Proceedings of the Madras Government, Revenue Department, 5th March 1869.

Treasure vaults in Bellary Taluk Cutcherries.—Board of Revenue to furnish explanation with reference to certain deviations from the standard plan.

Plan and Section of a Treasure vault for the Taluq Cutchery at Kovvinhudgully, District Bellary

TREASURY VAULT

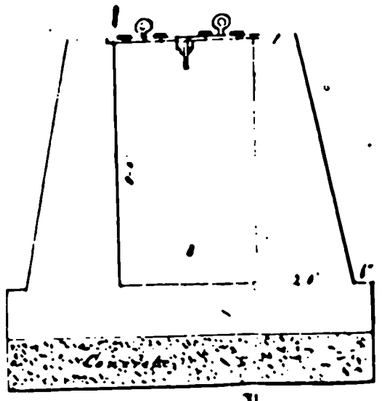
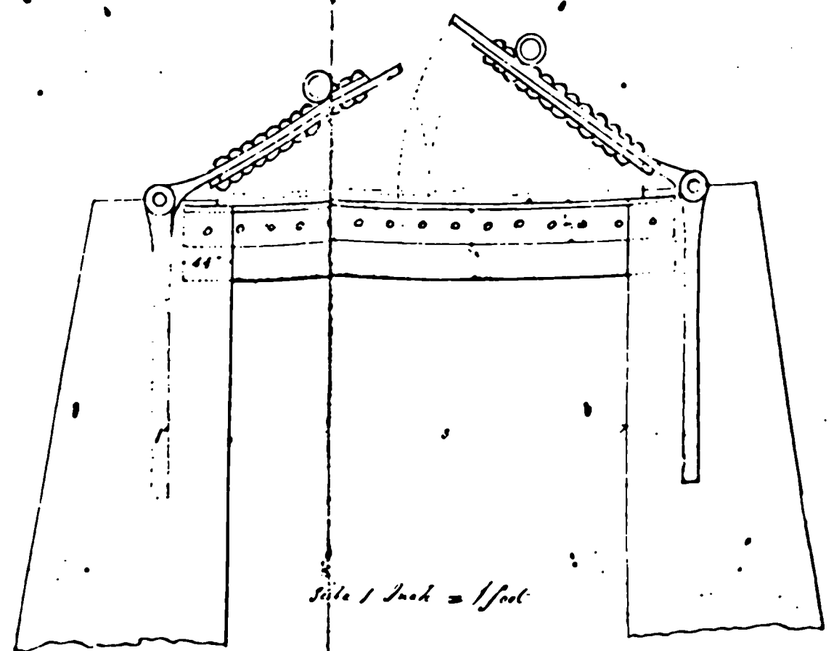
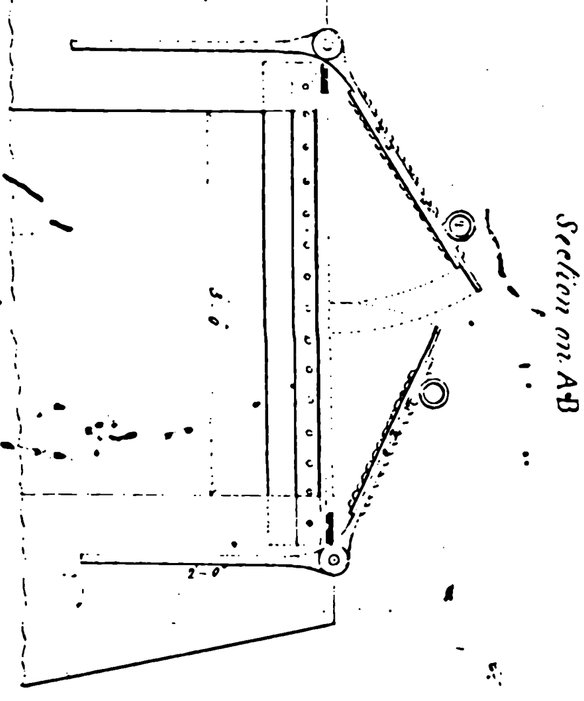
According to the Board's Standing Order No. 987, based on the Order of Government, dated 18th September 1866, No. 2,508, the vault is to be lined with cut stone, with a clear space inside, of feet 11-9 long by feet 5-9 wide and feet 6 deep; but the specifications now submitted provide for only 3×3×5 for each of the vaults, and the side walls and floor of that in the Talook Cutcherry at Hospett is to consist of brick-in-chunam. The Board of Revenue will be requested to furnish an explanation for this deviation from the instructions contained in the Orders alluded to.
